SECTION 00 91 13
ADDENDUM NUMBER 3

- 1.1 DATE: MAY 17, 2011
 - 1.2 PROJECT: ST. MARY'S 12 BED ICF/MR
 - 1.3 PROJECT NUMBER: 1990.10A
 - 1.4 OWNER: ST. MARY'S HOME FOR DISABLED CHILDREN
 - 1.5 ARCHITECT: PF&A DESIGN
- TO: PROSPECTIVE BIDDERS
- 2.1 This Addendum forms a part of the Contract Documents and modifies the Bidding Documents dated April 19, 2011, with amendments and additions noted below.
 - 2.2 Acknowledge receipt of this Addendum in the space provided in the Bid Form. Failure to do so may disqualify the Bidder.
 - 2.3 This Addendum consists of 2 Pages, 1 Specification Section and 1 Sketch:

CHANGES TO THE DRAWINGS - PROJECT 1990.10A ST. MARY'S 12 BED ICF/MR

**New Automatic
 Door at Existing
 Bus Vestibule**

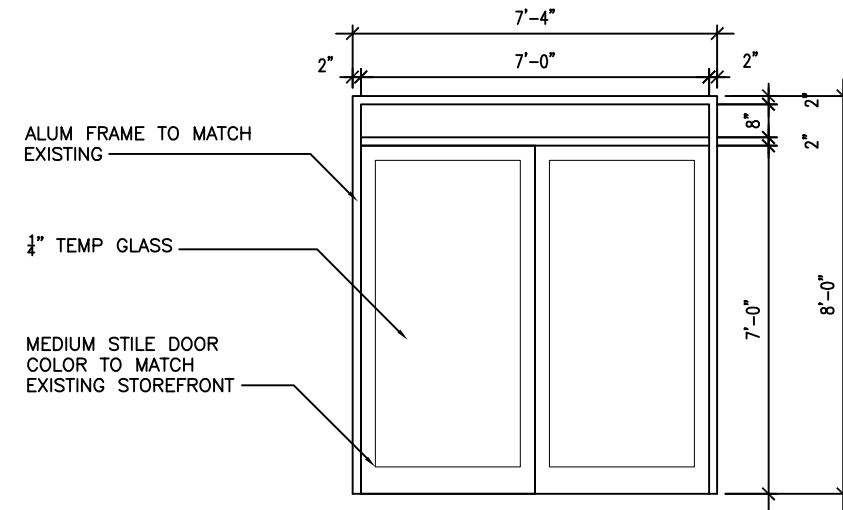
PROVIDE POWER OPERATOR TRANSFORMER AND ELECTRICAL CONNECTION AS REQUIRED TO INSTALL NEW DOOR.

PROVIDE CONTINUOUS HINGE

2"X4 1/2" FRAME
